CITY OF PORTLAND, MAINE

HISTORIC PRESERVATION BOARD MEETING

PUBLIC HEARING
54 YORK STREET

TO: Chair Pollard and Members of the Historic Preservation Board
FROM: Rob Wiener, Historic Preservation Compliance Coordinator
DATE: April 1, 2022
RE: April 6, 2022 **PUBLIC HEARING –Final Review of Proposed
Exterior Alterations - HPBR-001914-2022**

2 NORTH ELEVATION (MAPLE STREET)

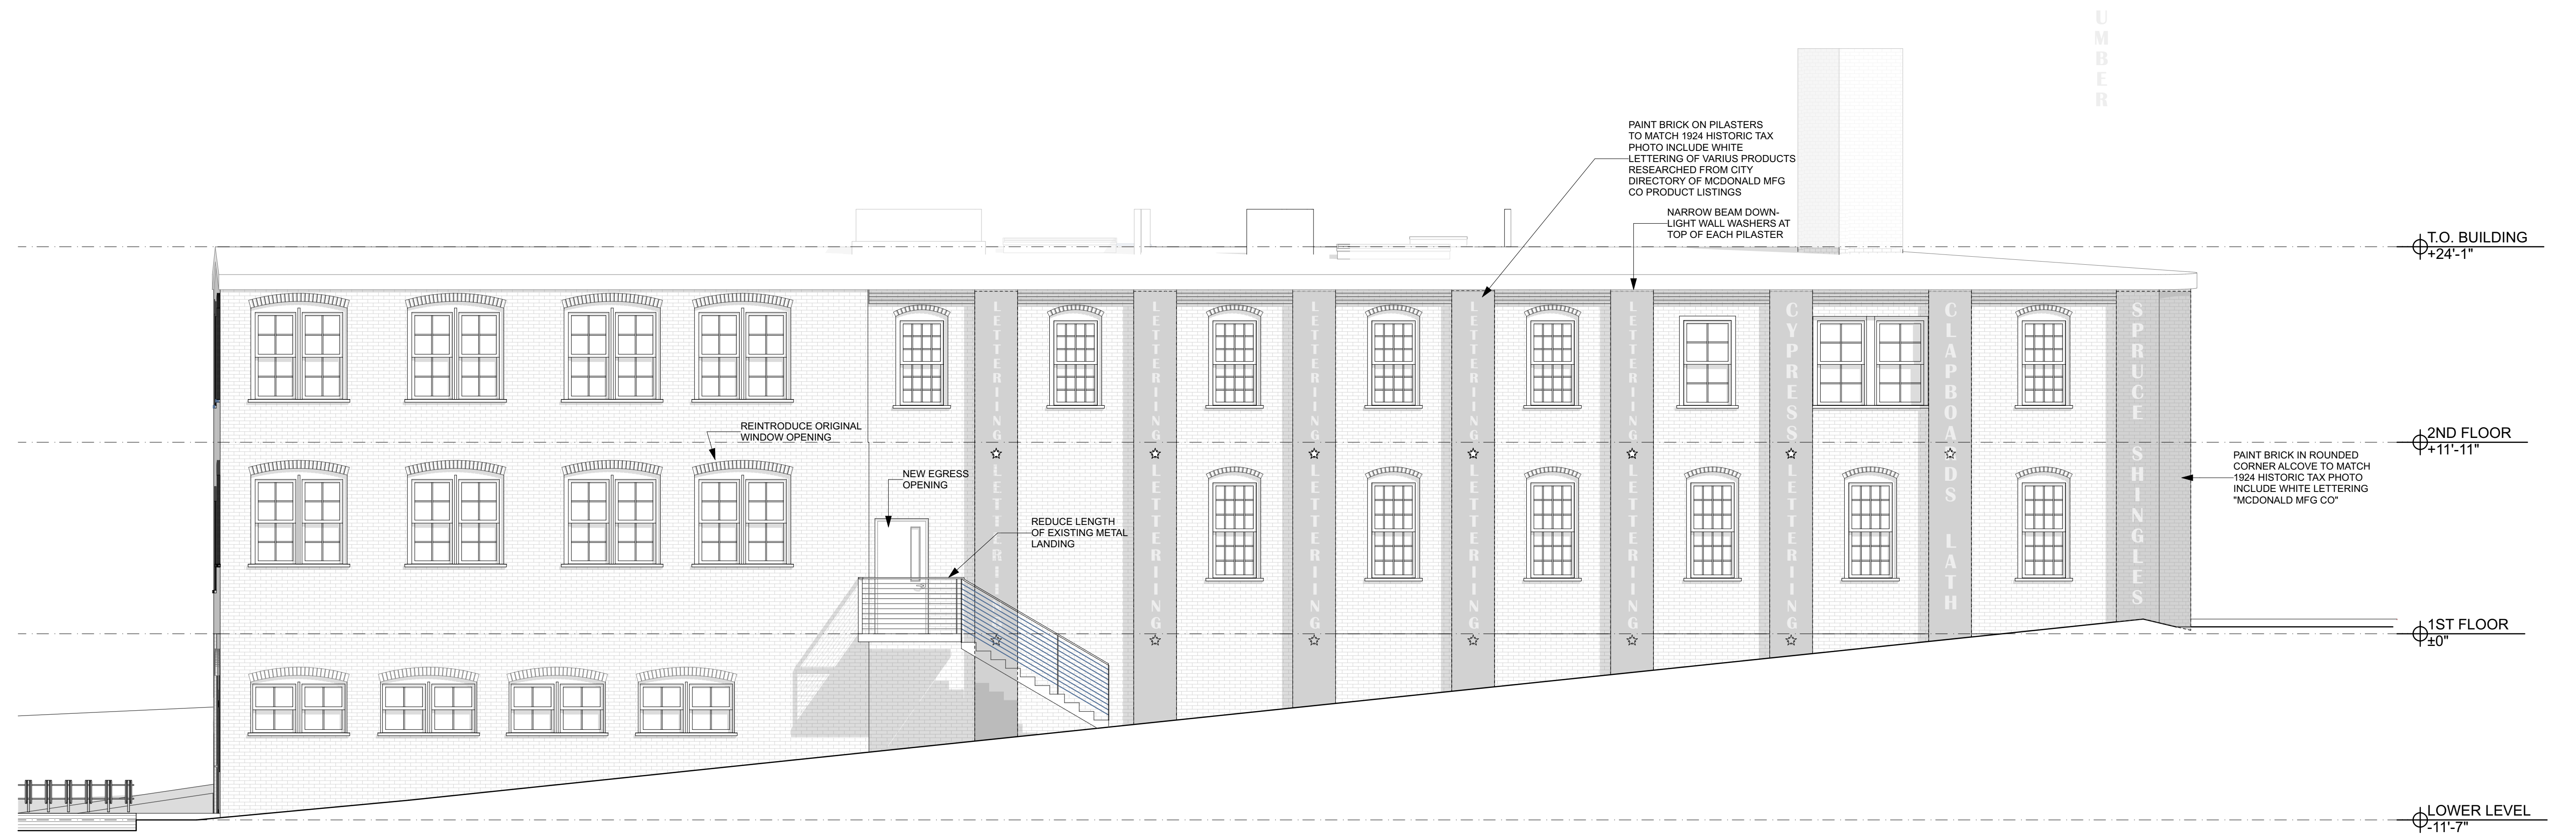
- West Facade (York Street): Revert (2) existing 2nd Floor openings to the size of original hoistways. Introduce (1) new 2nd Floor opening.
- North Facade (Maple Street): Relocate egress door and reintroduce historic window in its previous location.
- East Facade: No opening modifications.
- North Facade: Introduce (1) new opening at each the 1st and 2nd Floor. Introduce a new storefront along the Lower Level.

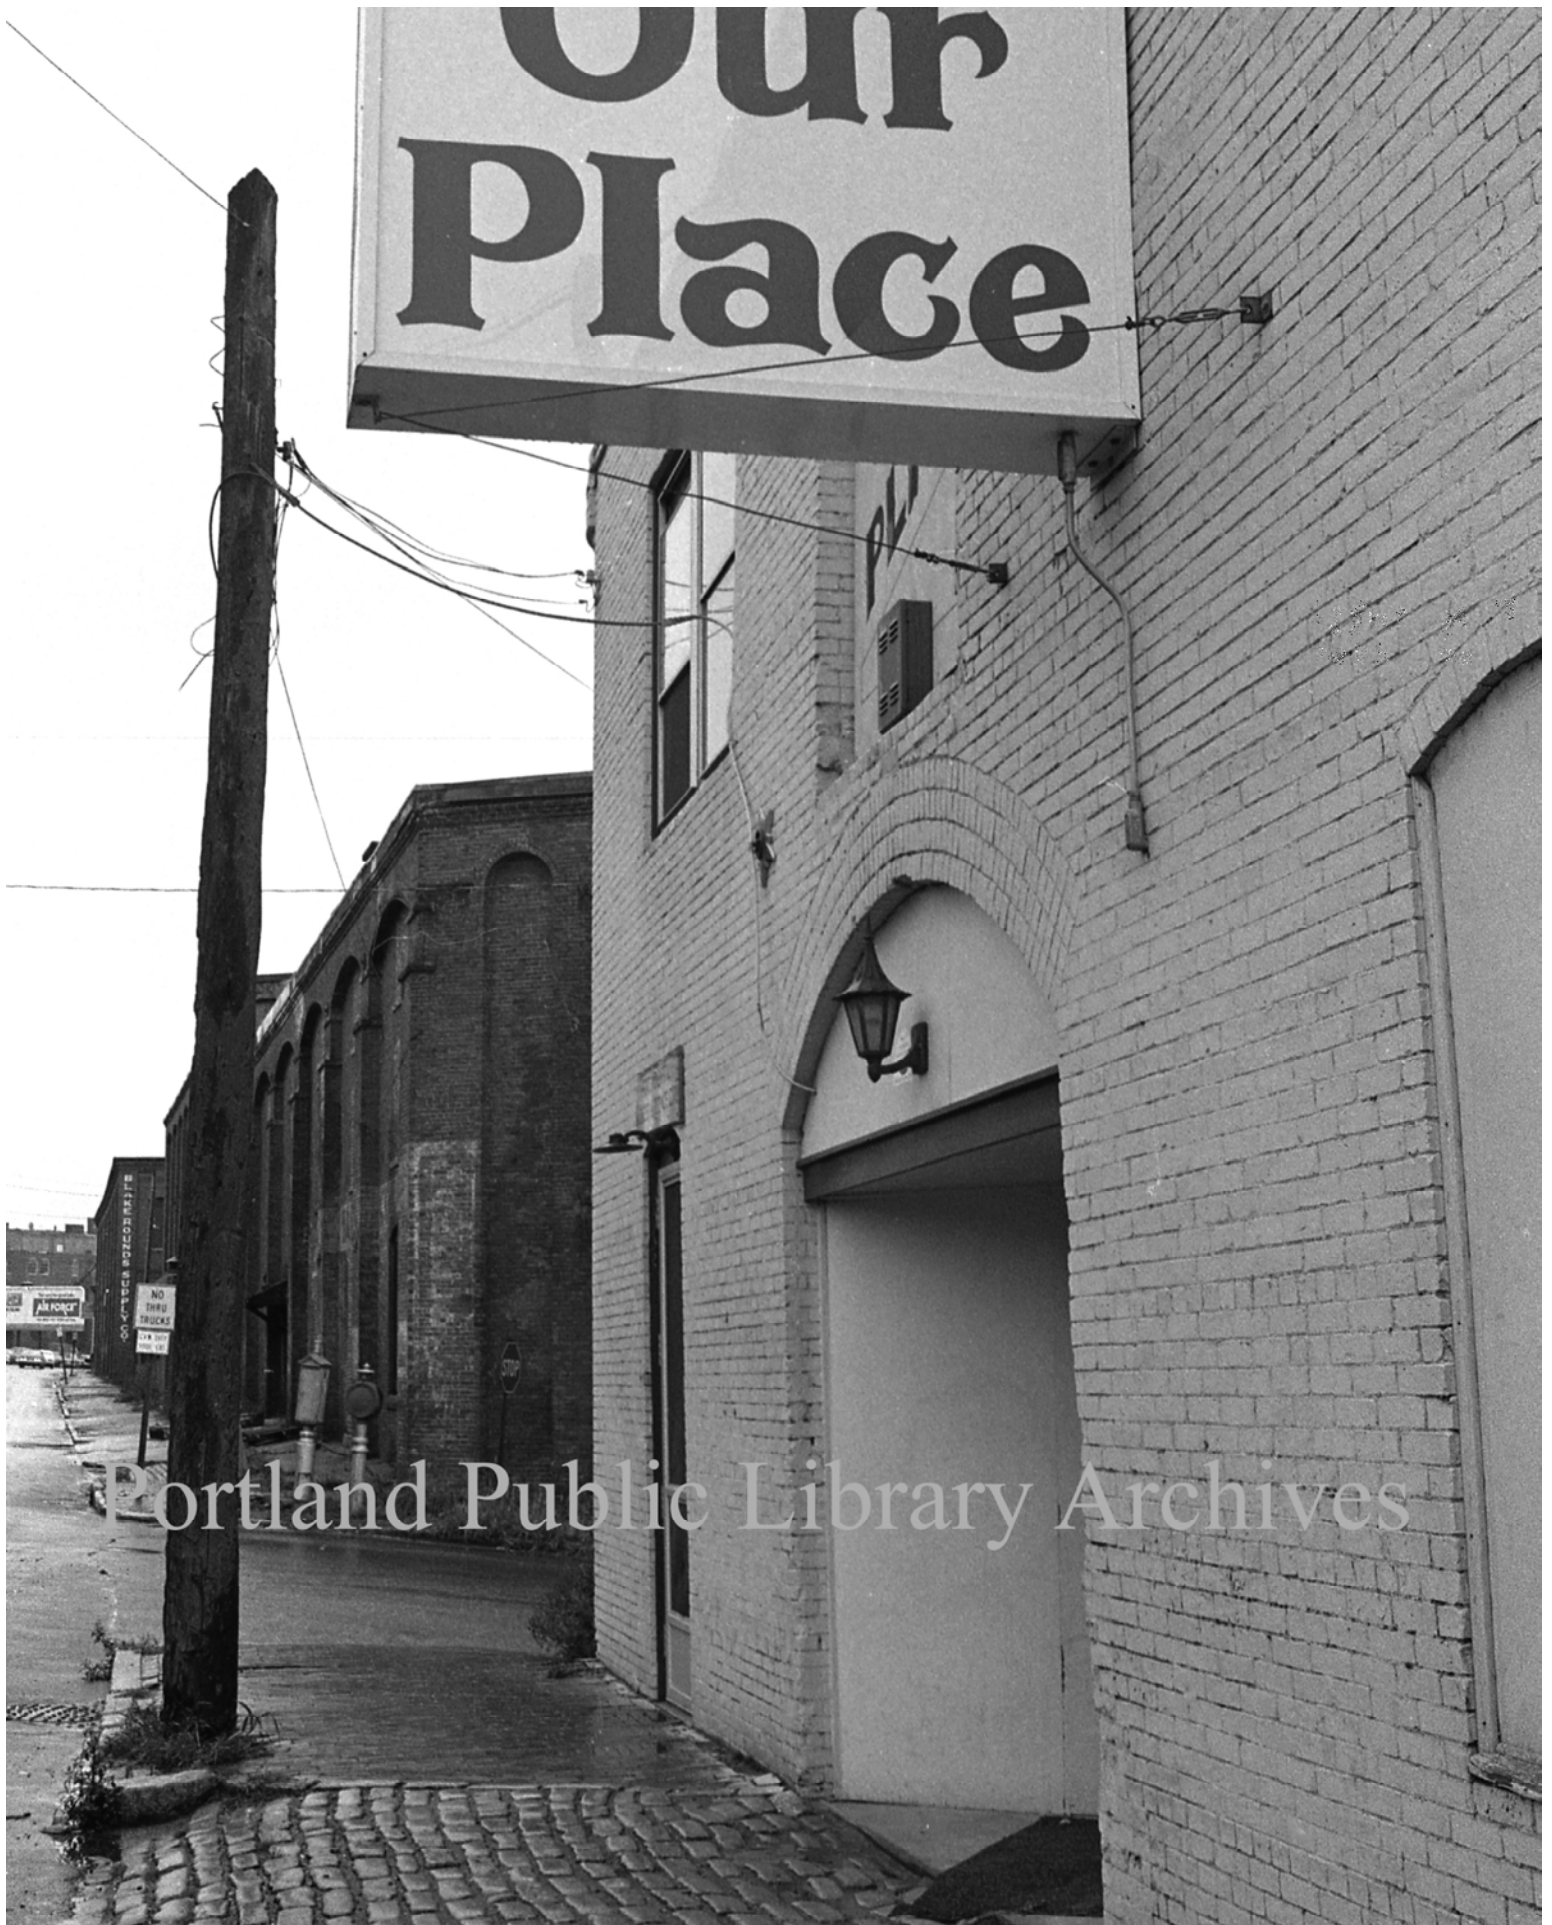
The images prompt a very big question for both the HPB and the National Park Service (along with the applicant): Has the "original" structure has been so compromised by historical change (both to the extant structure and its context) that it has lost its historical integrity and the story it purports to tell us today?

- loss of upper chimney and introduction of unhistoric chimney cap detail (the original chimney was uninterrupted along its entire length including at its culmination without any extraneous brickwork)
